<b>AMENDMENT OF SOLICITATION/MODIFICATION OF CONTRACT</b>			1. Contract Number	Page of Pages 1   22	
2. Amendment/Modification Number GF-2010-B-0006-004		3. Effective Date 7-May-10		4. Requisition/Purchase Request No.

14. Description of amendment/modification (Organized by UCF Section headings, including solicitation/contract subject matter where feasible.)					
Solicitation No. GF-2010-B-0006, Renovation of Plaza Deck and Parking Garage is hereby amended as follows:

## **Renovation of Plaza Deck and Parking Garage**

### **Revised Drawings List**

PARTIAL DWG. E-3

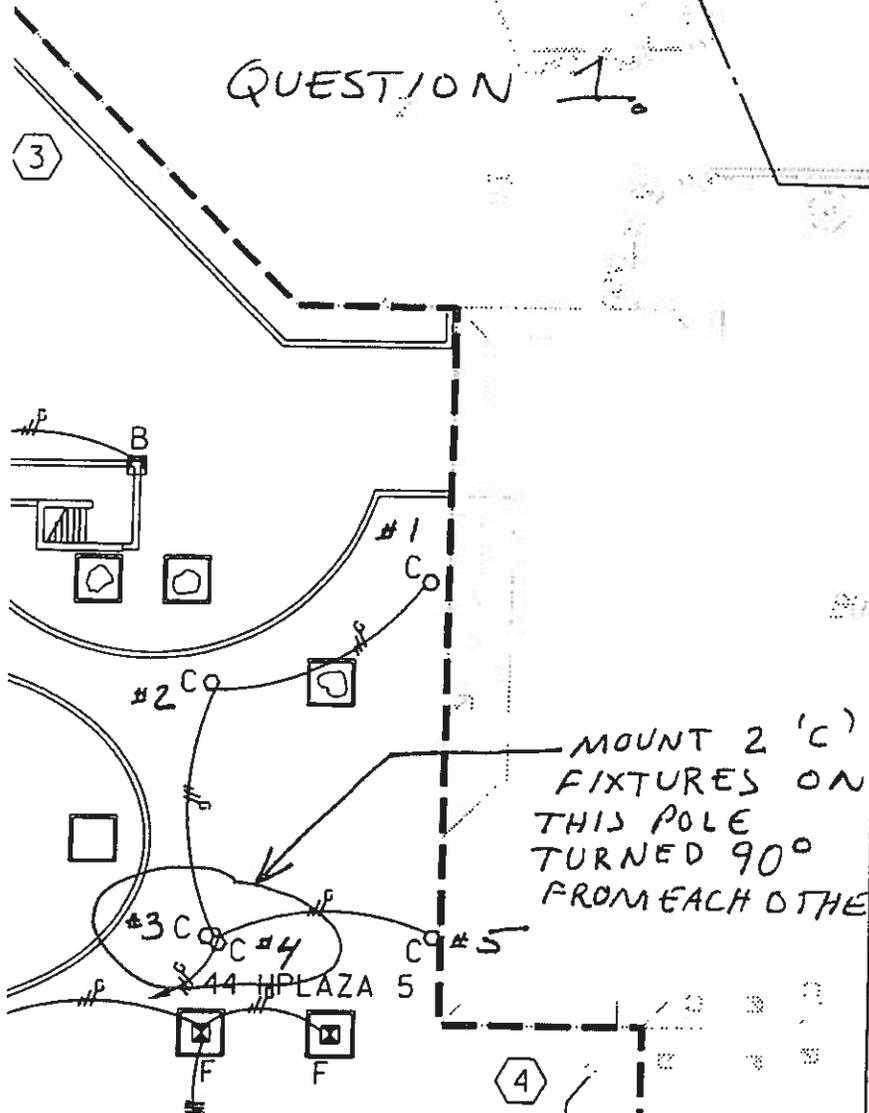
Quest No.	Question	Answer
1.	Reference Site Lighting Plan Sheet E-3, Material and Layout Enlargement Plans L-2 & L-3, and Site Detail Plan LD-15 Detail #4. The Light Fixture Schedule on sheet E-3 states that there is a quantity of 5 type "C" light fixtures required for this project. Site lighting plan E-3 and landscape plans L-1 & L-2 show only 4 type "C" light fixtures. Which quantity is correct? If a total quantity of 5 is required. Where is the 5th type "C" light fixture locate? Please clarify.	5 is the correct quantity of type "C" light fixtures. See attached enlargement of drawing E-3 for locations.

QUESTION 2

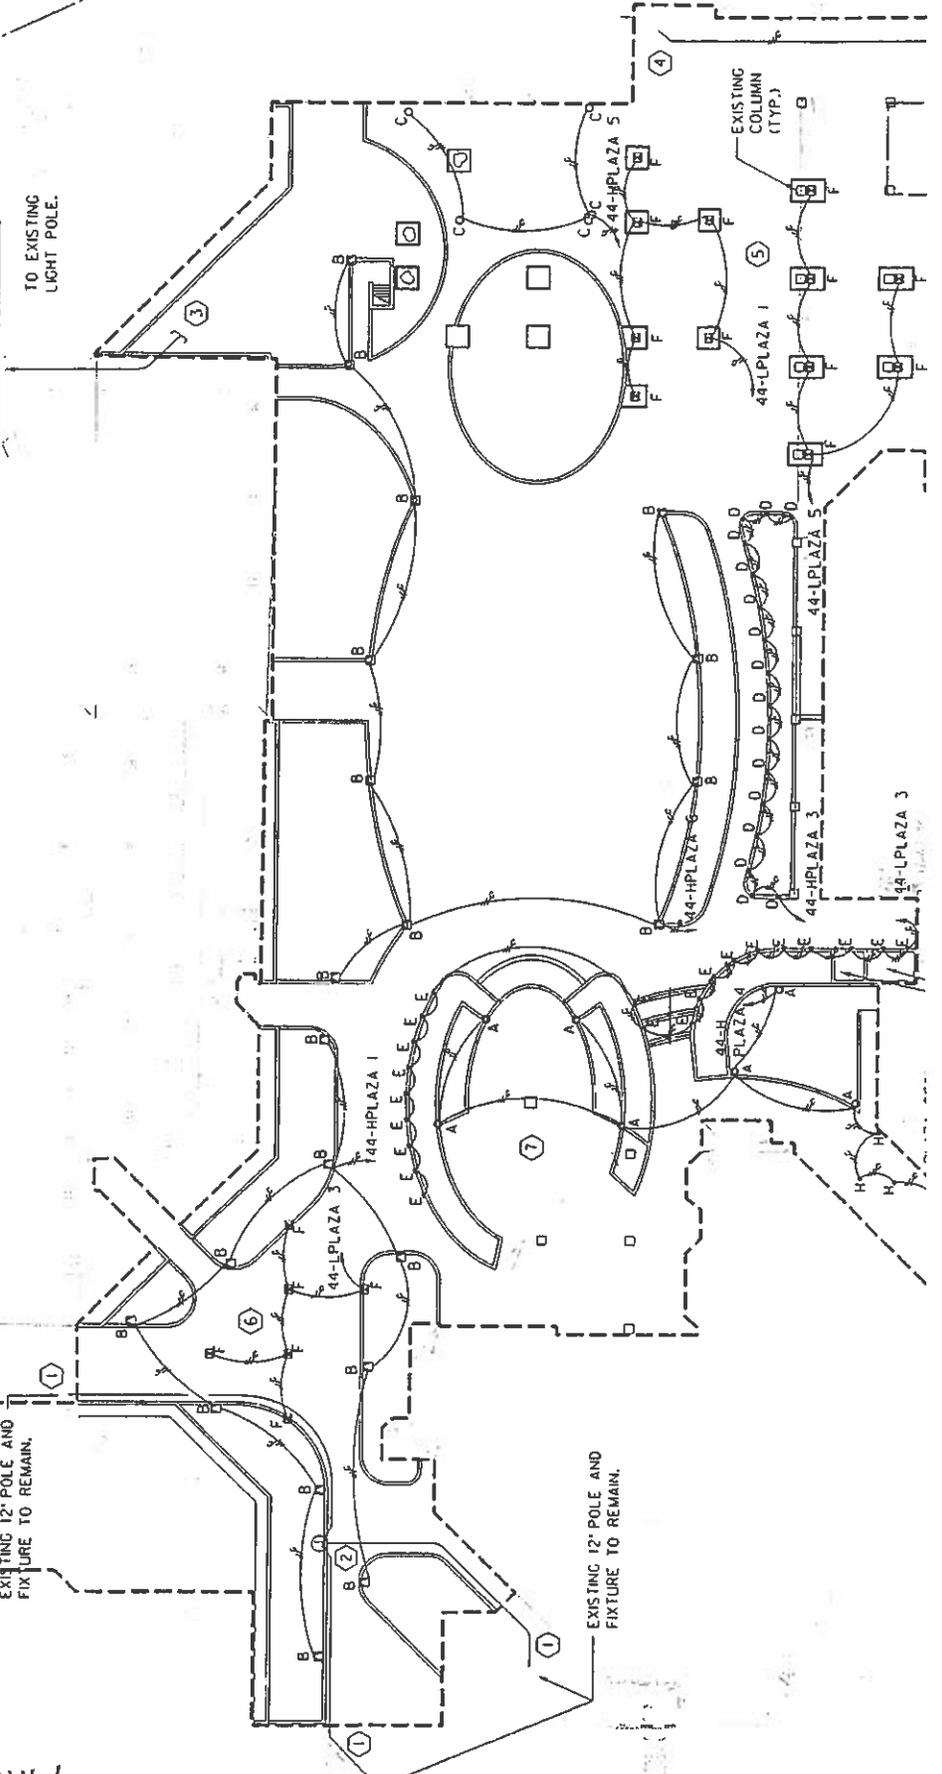
2.	Reference Site Lighting Plan Sheet E-3 and Material and Layout Enlargement Plans L-4 & L-5. The Light Fixture Schedule on sheet E-3 states that there is a quantity of 28 type "E" light fixtures required for this project. Site lighting plan E-3 and landscape plans L-3 & L-4 show 21 type "E" light fixtures. Which quantity is correct? Please provide the location of the other 7 type "E" light fixtures.	21 is the correct number of type "E" light fixtures. See attached enlargement of drawing E-3.

QUESTION 3  
PARTIAL E-6

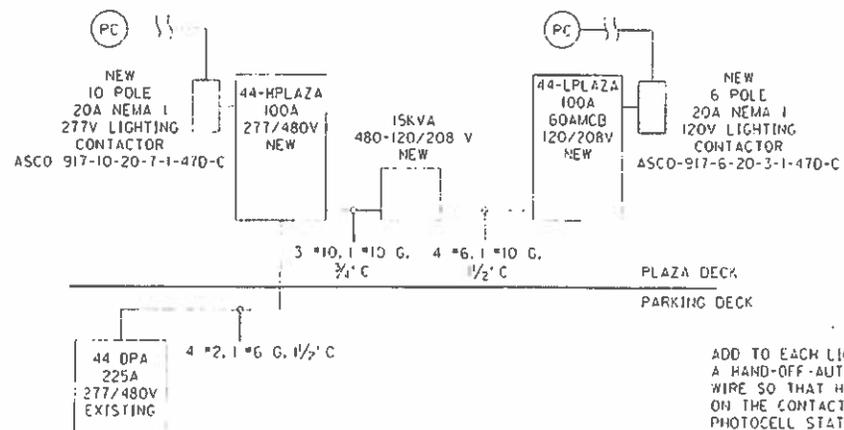
3.	The single line diagram on sheet WE-4 states that the feeder for the Fountain Power Distribution Center is to be specified by others. Is the feeder for this equipment part of this contract? If so, what size is the feeder and where is it fed from? Please clarify.	WE-4 says "SEE DWG. E-6". Drawing E-6 shows a 150A feeder breaker to be added to CKTS 7, 9, 11 in existing panel 41-DPA. Feeder cable is shown to be 4 # 1/0, 1 # 6 ground, 2" conduit. See drawing E-6, attached (partial).

150 AMP BREAKER FOR FOUNTAIN EQUIPMENT SHALL BE SHUNT TRIP. CONNECT SHUNT TO THE FLOAT SWITCH PROVIDED WITH THE FOUNTAIN EQUIPMENT. RISING WATER SHALL TRIP THE BREAKER, KILLING POWER TO THE FOUNTAIN EQUIPMENT.

2 ABOVE GROUND STORAGE TANK FACILITY NO. 2  
NOT TO SCALE

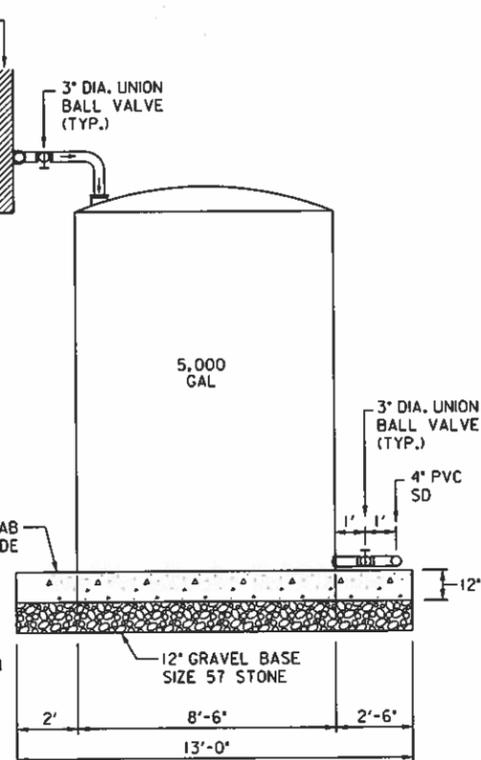
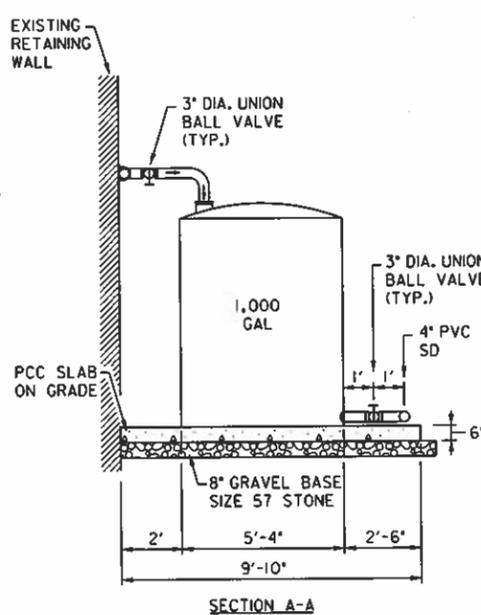
the building roofing system.
9.	Drawing D-3 shows 5,000 gallon and 1,000 gallon cistern. There isn't any specification section given for these cisterns. Please provide specification section for these cisterns.	Above ground storage tanks, 1,000 and 5,000 gal. capacity, shall be vertical plastic water tanks, dark green color, model 41686 and 40870 as manufactured by Norwesco Inc. or approved equal.
